CRIGLER INDUSTRIAL PARK SUBDIVISION, RESUBDIVISION OF LOTS 5, 6, & 7

Engineering Comments: FINAL PLAT COMMENTS (should be addressed prior to submitting the FINAL PLAT for review and/or signature by the City Engineer):

SITE PLAN

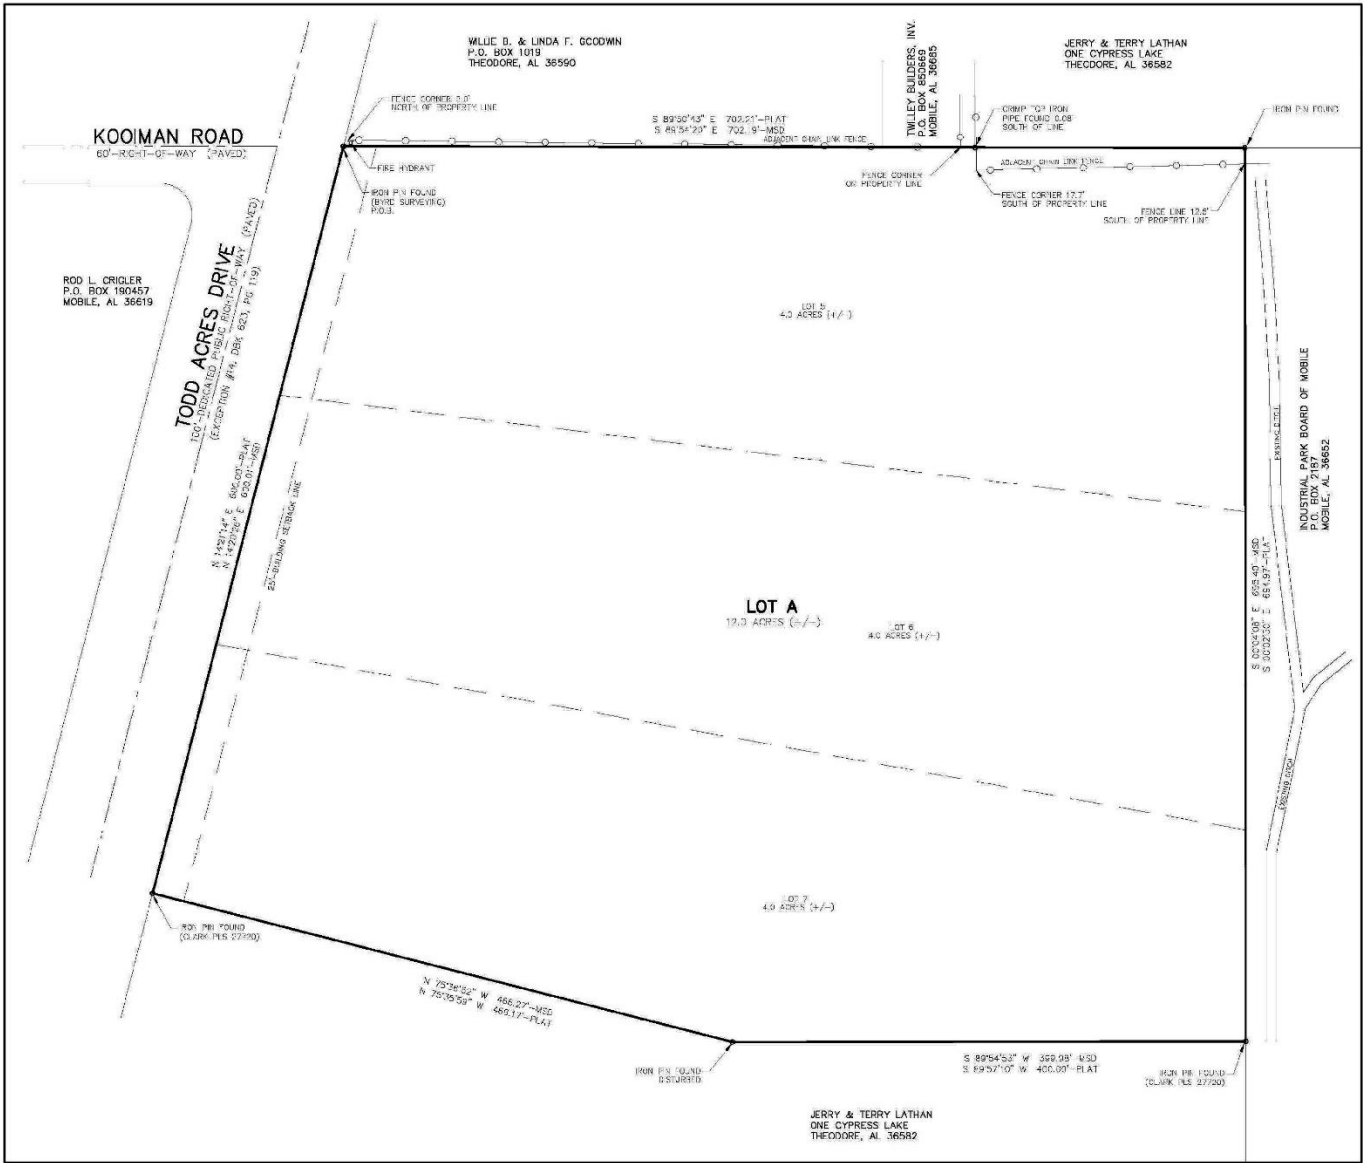
The site has frontage on Todd Acres Drive, a minor street with curb and gutter, which has an existing, compliant 100-foot right-of-way; therefore, no dedication would be required. As on the preliminary plat, the right-of-way width of Todd Acres Drive should be retained on the Final Plat, if approved.

The preliminary plat submitted indicates a proposed 25-foot minimum building setback line along Todd Acres Drive, and this should be retained on the Final Plat, if approved.

The proposed Lot A is approximately 12± acres which exceeds the minimum size requirements of the Subdivision Regulations. If approved, the Final Plat should be revised to illustrate Lot size in both square feet and acres, or provision of a table on the Final Plat providing the same information.

The preliminary plat does not depict any existing easements on site. However, if any easements are present on the site, if approved, a note should be placed on the Final Plat stating that no structure is allowed in any easement, without the approval of the easement holder.

Regarding access management, a note should be placed on the Final Plat stating the Traffic Engineering comments, if approved.

- 1) retention of the right-of-way width of Todd Acres Drive on the Final Plat;
- 2) retention of the 25-foot minimum building setback lines along Todd Acres Drive on the Final Plat;

- 3) revision of the Final Plat to illustrate the Lot size in both square feet and acres, or provision of a table on the Final Plat providing the same information;

- 4) placement of a note on the Final Plat stating that no structure is allowed in any easement, without the approval of the easement holder, if applicable;
